**ADDENDUM NO. 1**

**CID 01-STILLHOUSE BRANCH WASTEWATER TREATMENT FACILITY  
IMPROVEMENTS**

**PROJECT NO.: 2-01590 | TWDB CWSRF NO. 73776**

**DATE OF ADDENDUM: MAY 24, 2023**

PM J. JENKINS  
DESIGNED M. CLOUGH  
DRAFTED TFG, PA  
CHECKED J. JENKINS  
PROJECT NO. 2-01590  
DRAWING NO. C-09

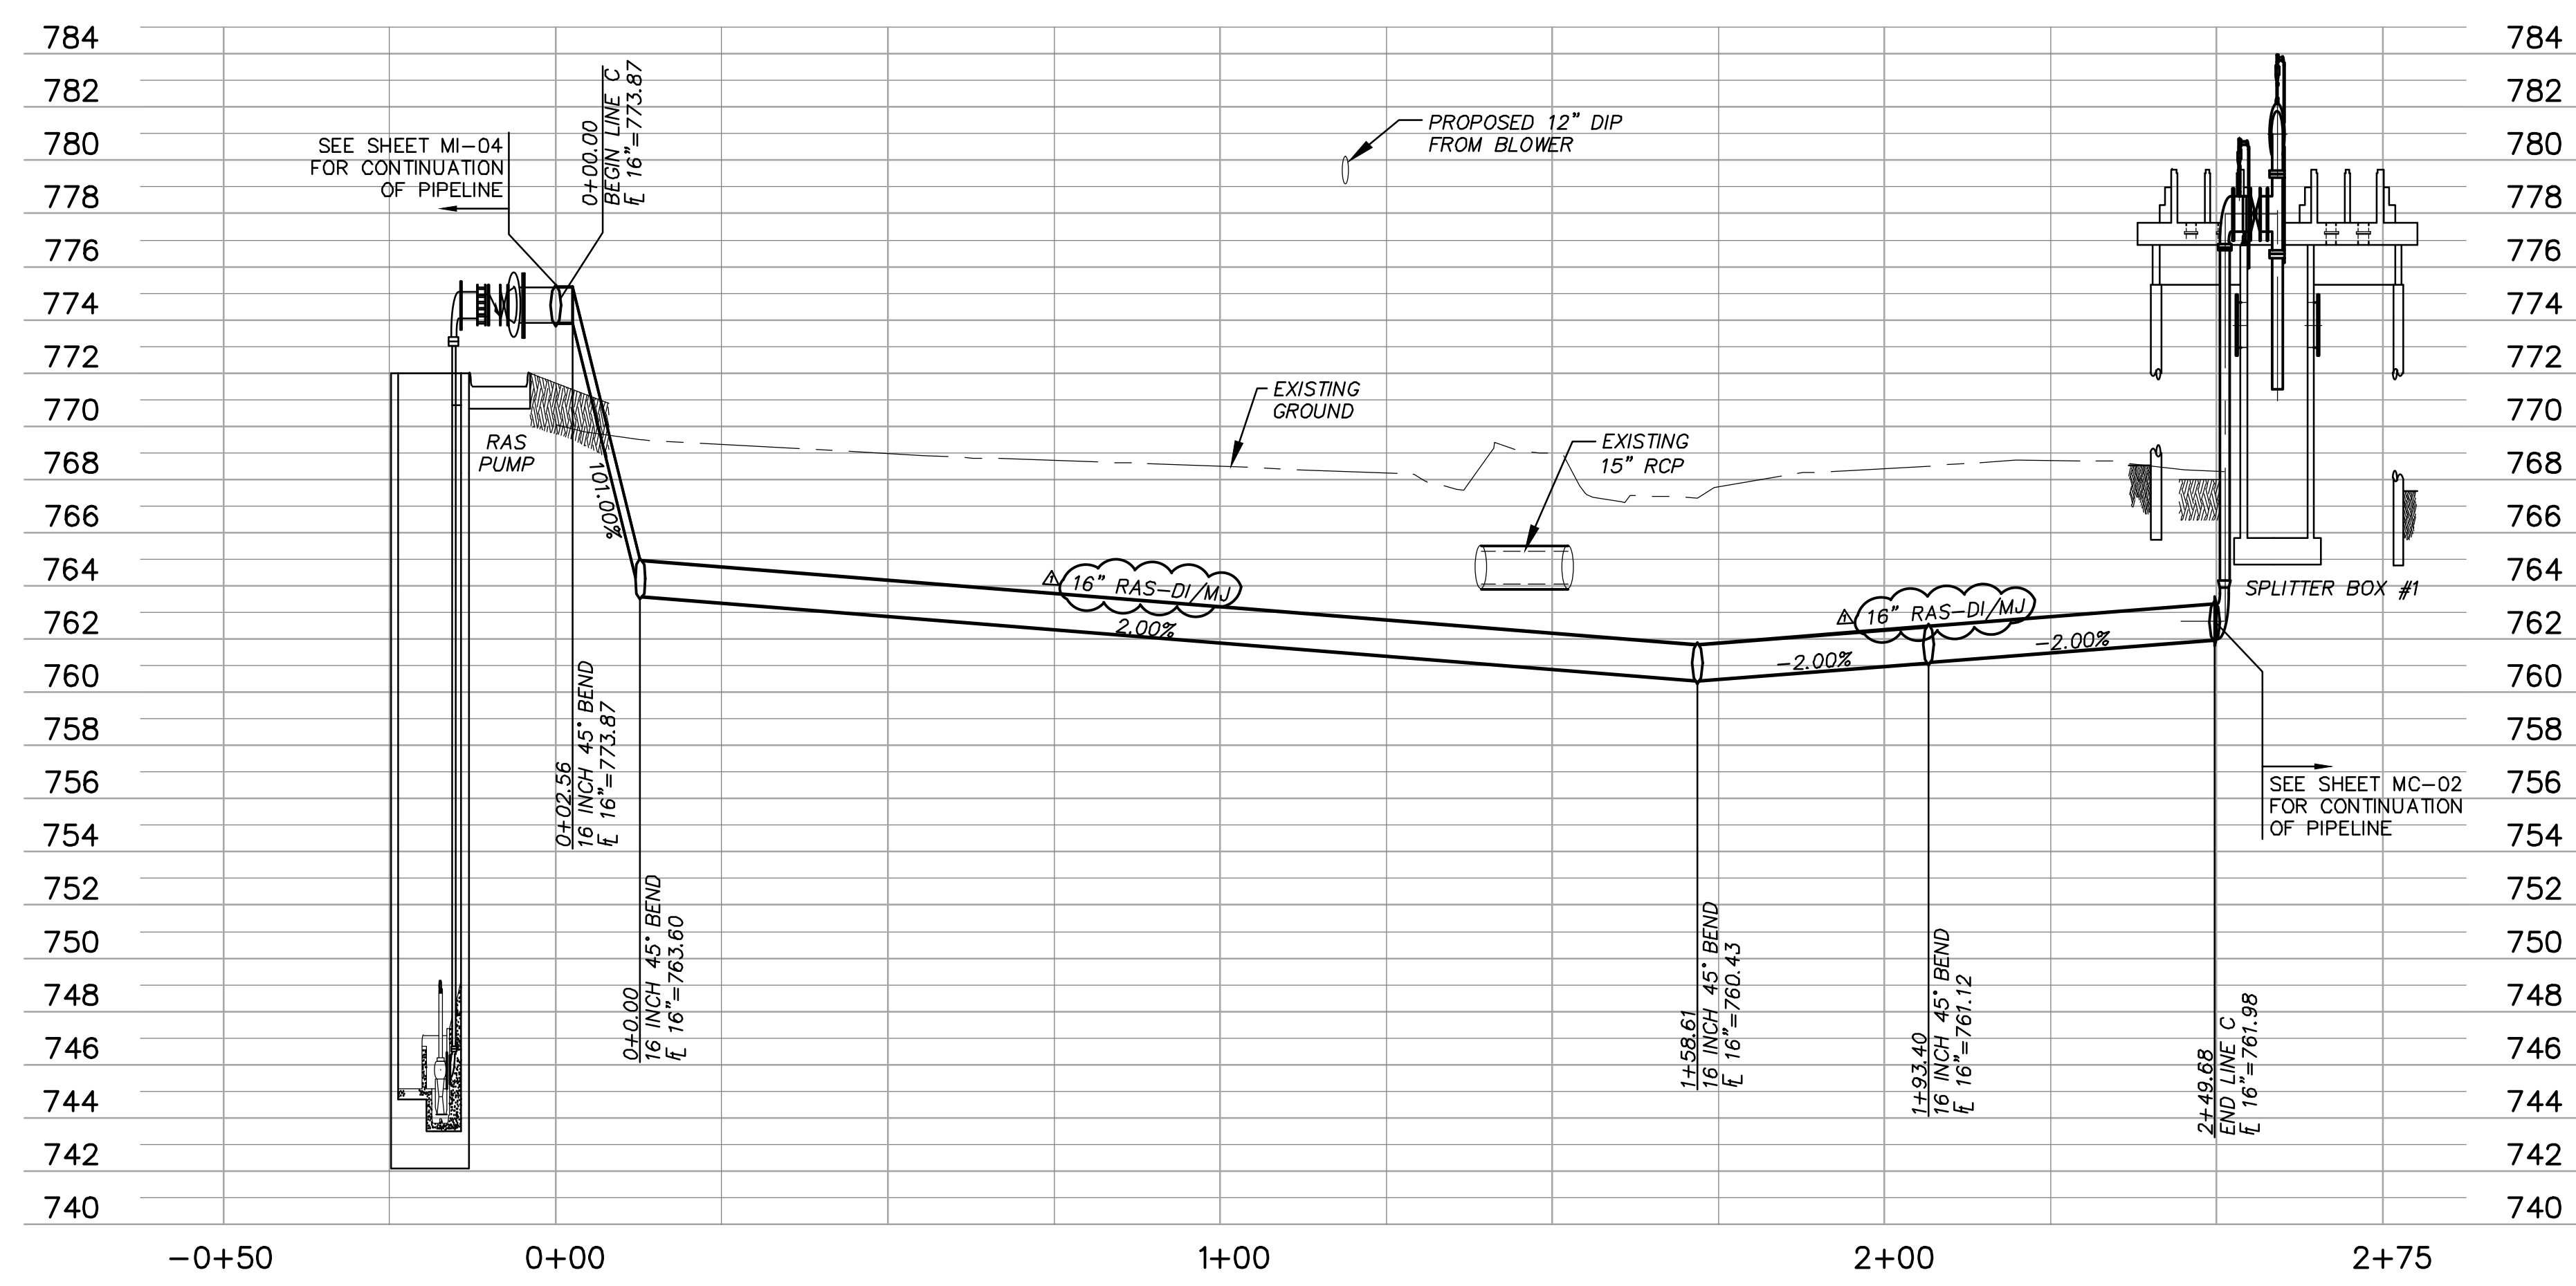
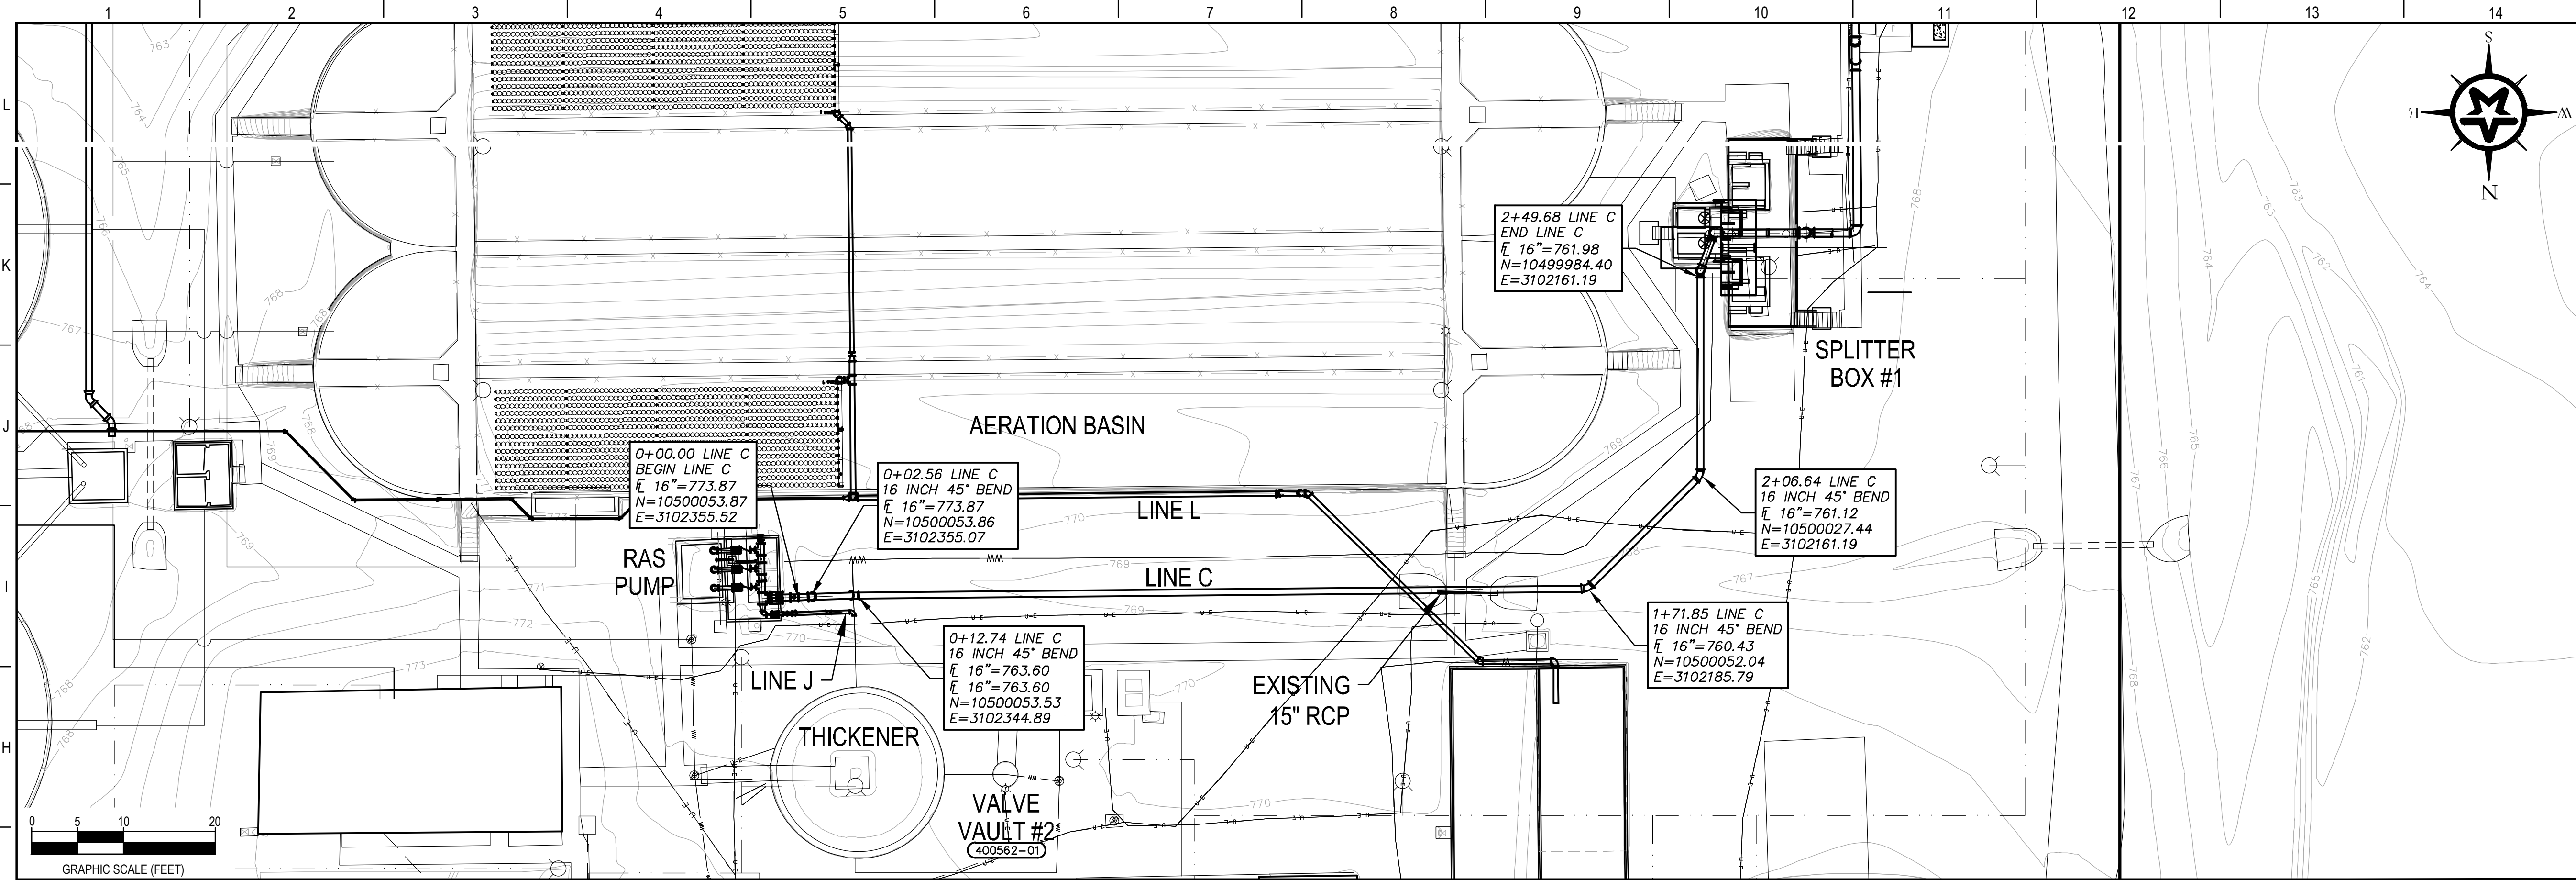
a. Sheets C-08 through C-17

REVISE yard piping to reflect the pipe labels on Sheet M-01 and Sheet M-02.
